SIB 52 06 22

2ND ROW PASSENGERS SEAT INTERMITTENTLY WON'T LATCH

This Service Information Bulletin (Revision #1) replaces SI B52 06 22 **dated September 2022**.

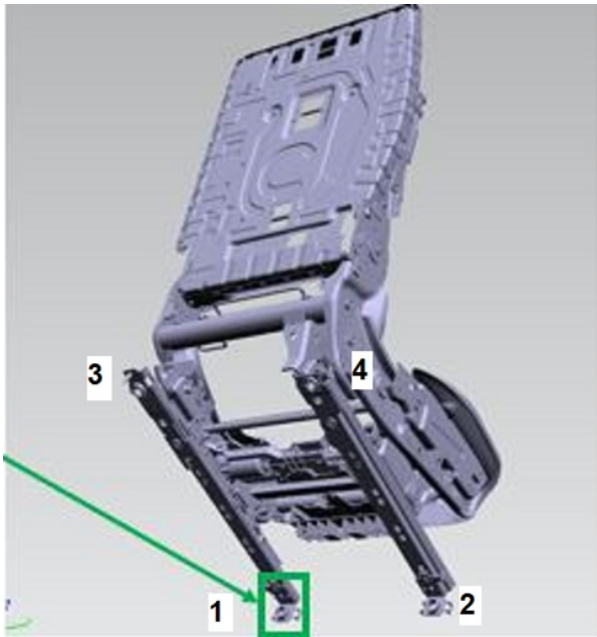
1. Precondition – Ensure all seats are properly initialized.

<p>A quick test to see if they are initialized (if equipped with third row power seats) is-</p> <ul style="list-style-type: none"> • Access the rear switches in the D pillar area • Push the button for maximum cargo space
--	--

- Alternatively, push this button for maximum seating.
- Intended result:
- All 2nd and 3rd row seats should move
